Novi Plaza SP 10-30

Consideration of the request of T.S. Quatro Company, Inc. for Preliminary Site Plan approval and a Section 9 Façade Waiver. The subject property is located at 41431 through 41563 Ten Mile Road, on the south side of Ten Mile Road, west of Meadowbrook Road in the B-1, Local Business District. The applicant is proposing to redesign the façade of the existing Novi Plaza.

Re: **FACADE ORDINANCE REVIEW**
Novi Plaza Exterior Remodel, SP10-30
 Façade Region: 1, Zoning District: B-1

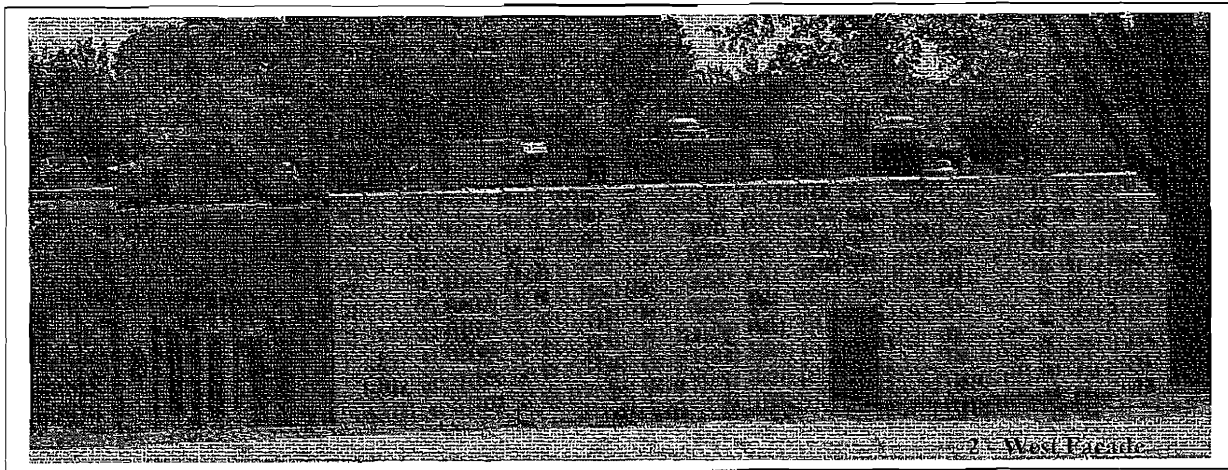
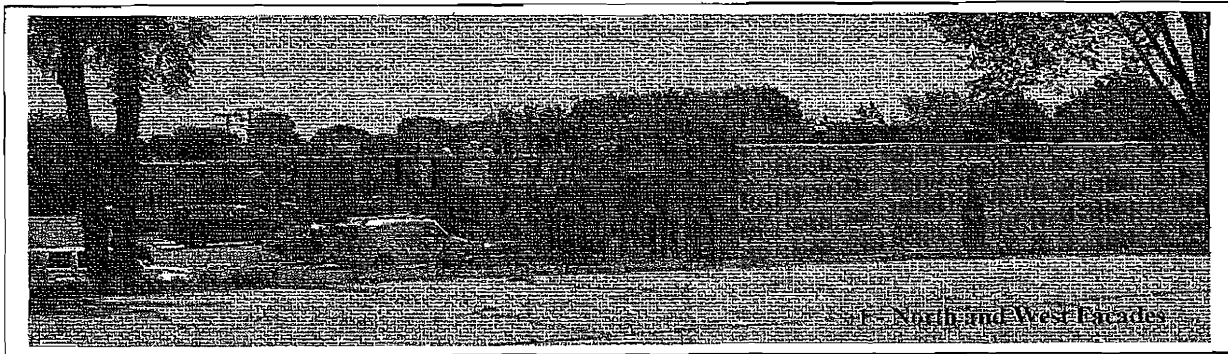
Numerous roof appurtenances currently visible on the building are a significant detracting element. It appears that these will be substantially screened from view by the proposed design with the extension of the parapet above the current roof line. The applicant should clarify that the proposed parapet extension (alternately 3 feet and 5 feet) are adequate to conceal all roof appurtenances. This analysis should take into consideration the fact that the topography to the west is elevated relative to the building making the roof appurtenances more visible from that direction (Photos 1 & 2 below).

East and West Facades (unaltered) - The proposed alteration to the north facade represents a significant improvement to the overall aesthetic value of the center. It is noted however that the lack of roof screening when viewed from the building's sides (east and west) may somewhat compromise the desirable affects achieved on the front. This is particularly true of the west side due to the aforementioned topographic condition. For that reason it is recommended that the applicant consider adding similar parapet extensions or other screening devices as required to screen the roof appurtenances from view from 10 Mile Road on the east and west facades.

1. Incorporation of a projected chamfered sill unit as a transition above the Split Faced C.M.U..
2. Addition of extended parapets or other screening methods on the east and west facades as required to conceal roof appurtenances from view from 10 Mile Road and adjoining properties.

Response: A 2' high masonry parapet (8" Block) will be added on the east and west facades
